01 Buildings 16 & 16a - Typical Glasshouse Gutter Detail
860.2 SCALE 1:5 @ A1

Job: TH - Walled Garden Buildings

Title: Buildings 16 & 16a - Typical Details

Status: FOR PLANNING

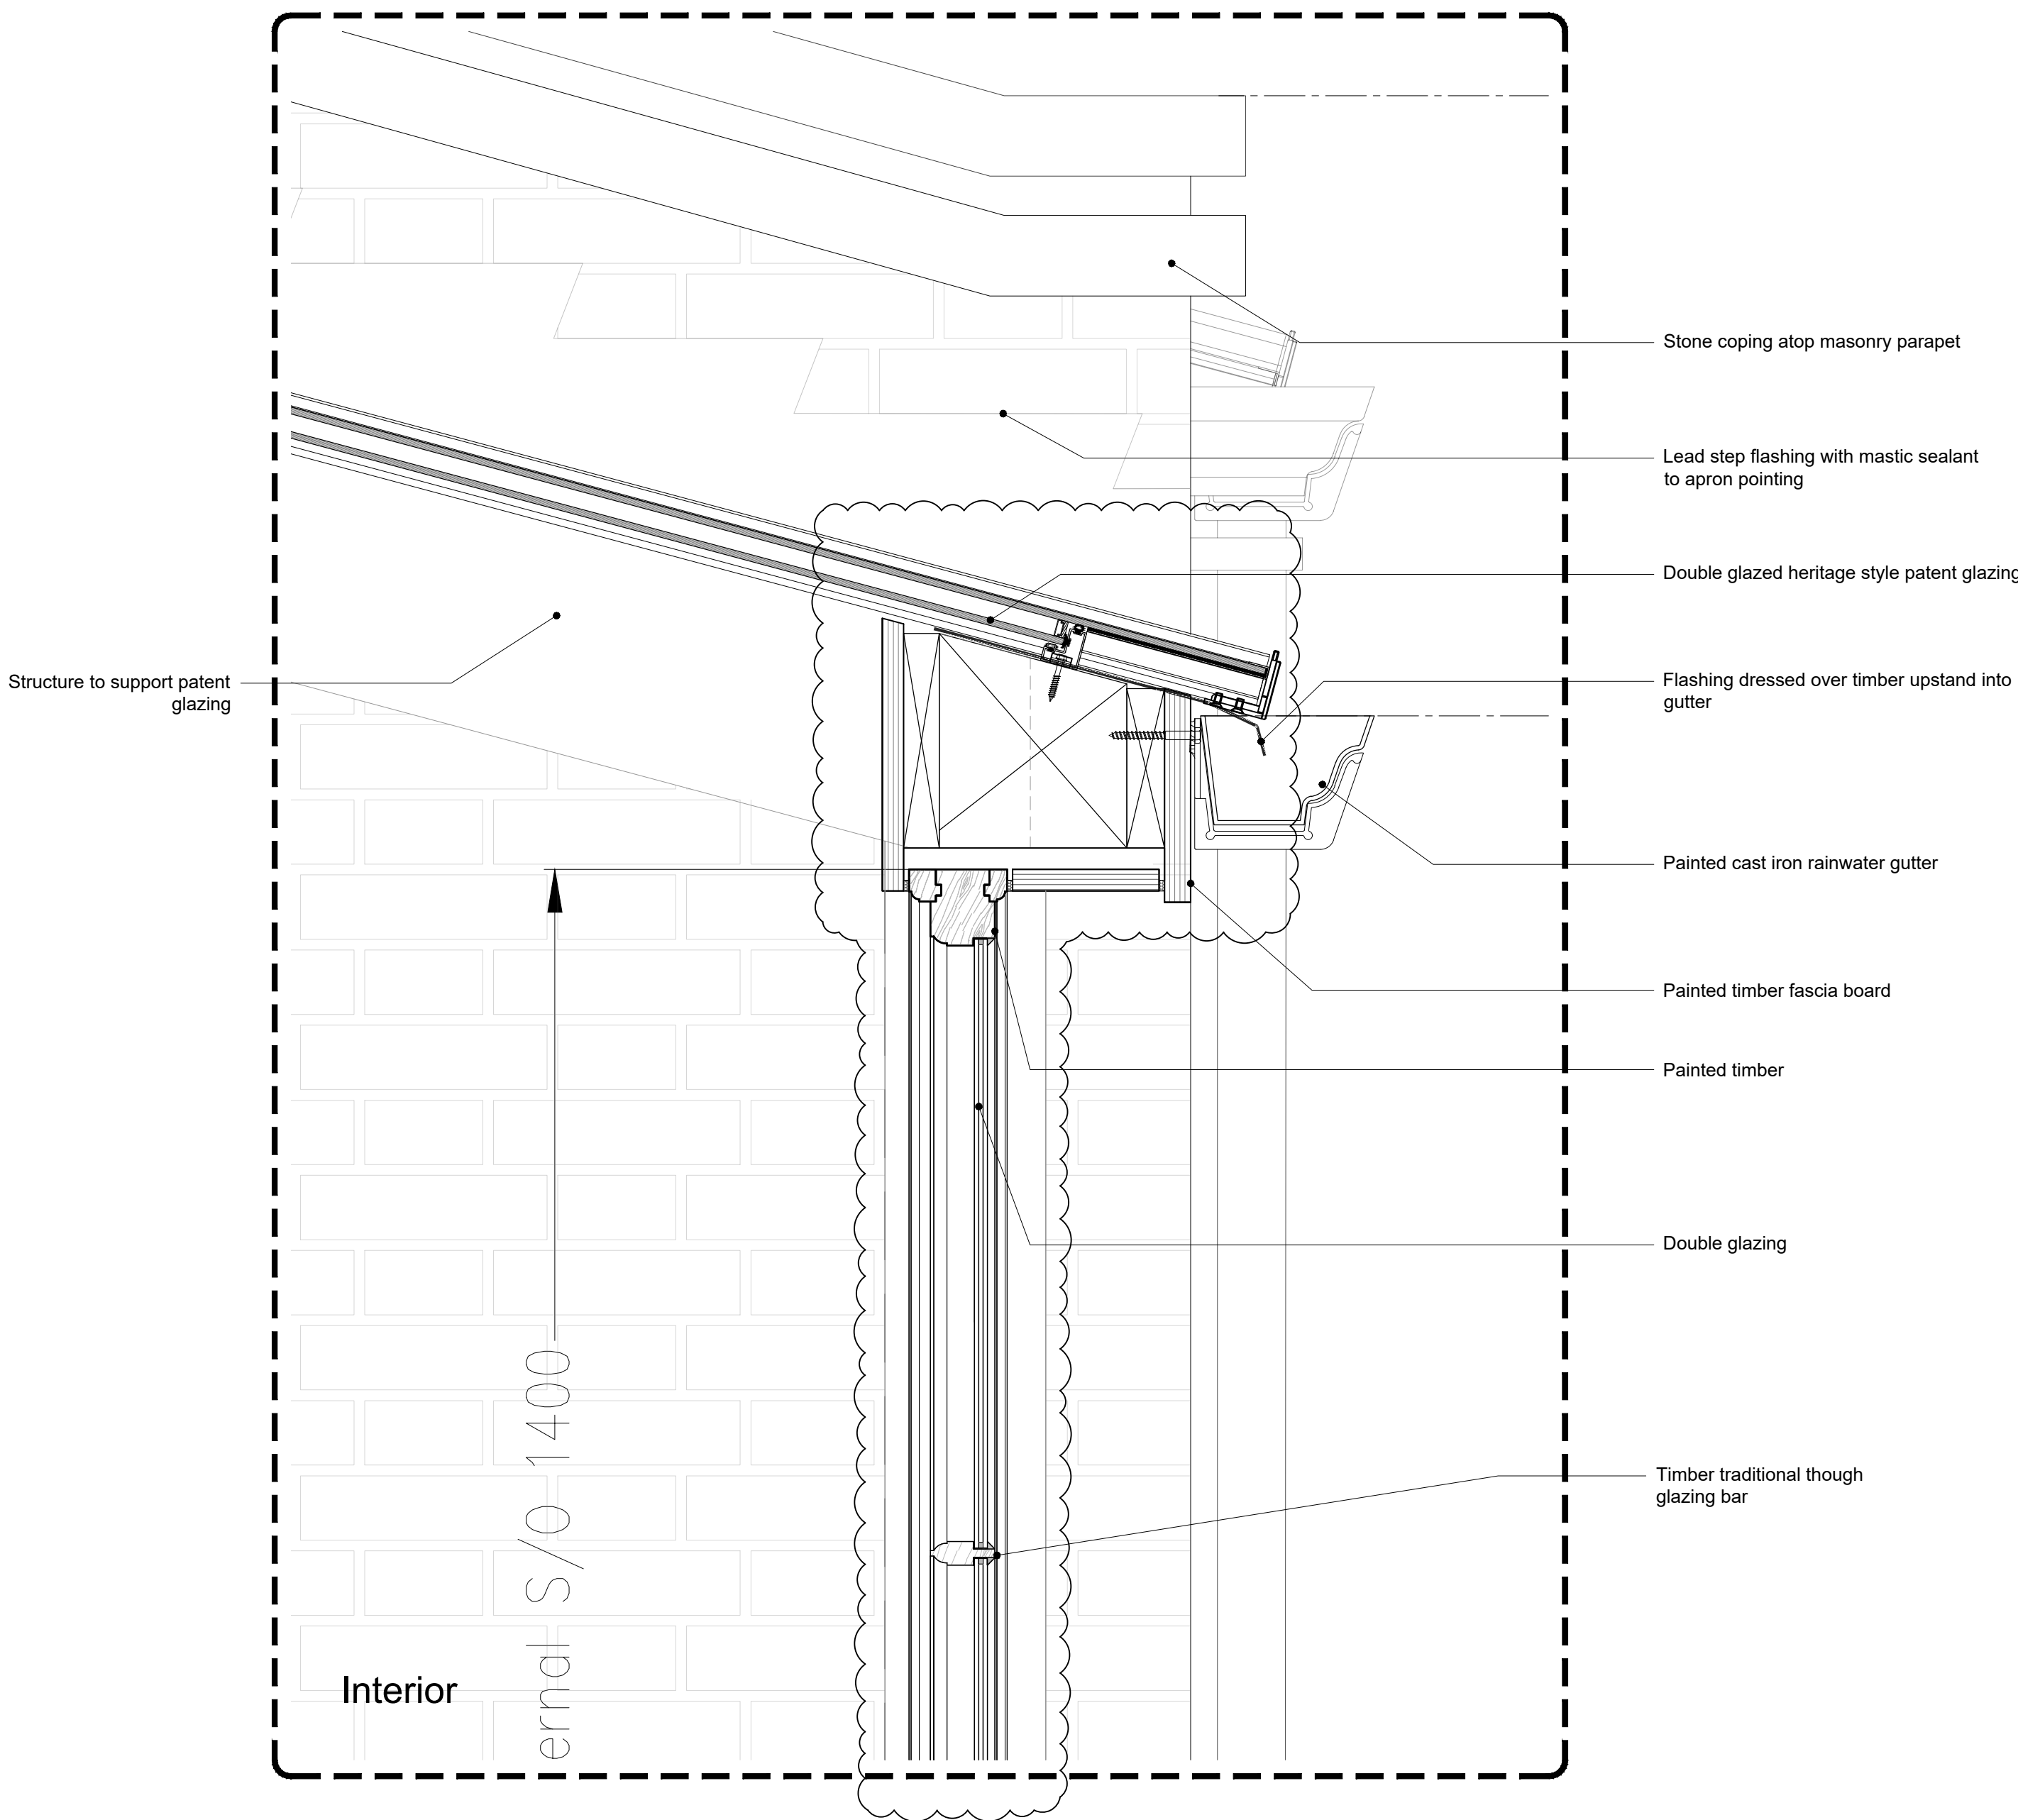
P2 Glazing bars amended to traditional timber through
glazing bars as Officer's comments. Scale Bar 27/03/26
Amended.
P1 Initial Release dd/mm/yy
no. revision. date.
